### STAFF RECOMMENDATION

622 Shelby Avenue

February 21, 2018

**Application:** New construction—detached accessory dwelling unit

622 SHELBY AVE.

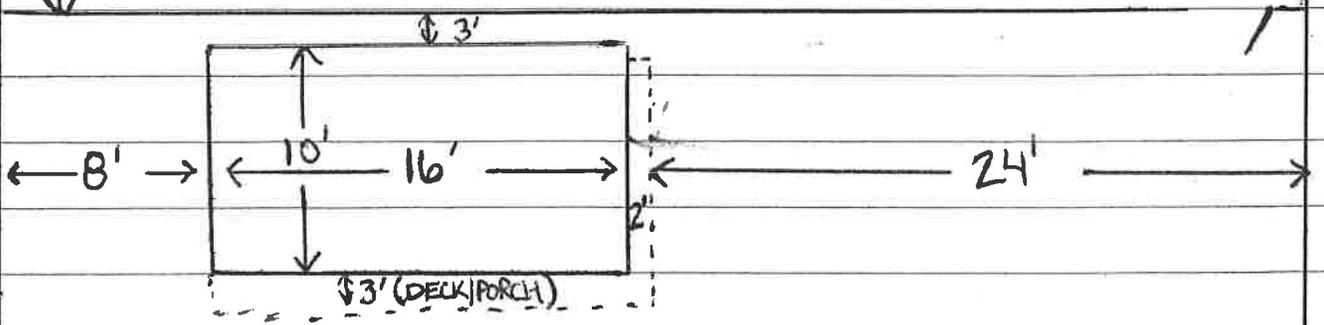
The applicant intends to add a covered deck to the exterior of the outbuilding. The site plan shows that the deck will be three feet (3') along the rear of the structure and two feet (2') deep along the right/east side. The applicant did not submit elevation drawings for the porch, but provided a photograph of how he envisioned the porch will look (Figure 5). Staff recommends receipt of elevations drawings that show the dimensions and design of the covered deck.

1. The windows be replaced with windows that meet MHZC standards for materials and configuration;
2. Battens be installed over the scoring of the cladding;
3. The applicant provide drawings showing the design of the new covered deck; and
4. Staff receive a copy of the filed restrictive covenant for the detached accessory dwelling unit prior to issuance of a permit.
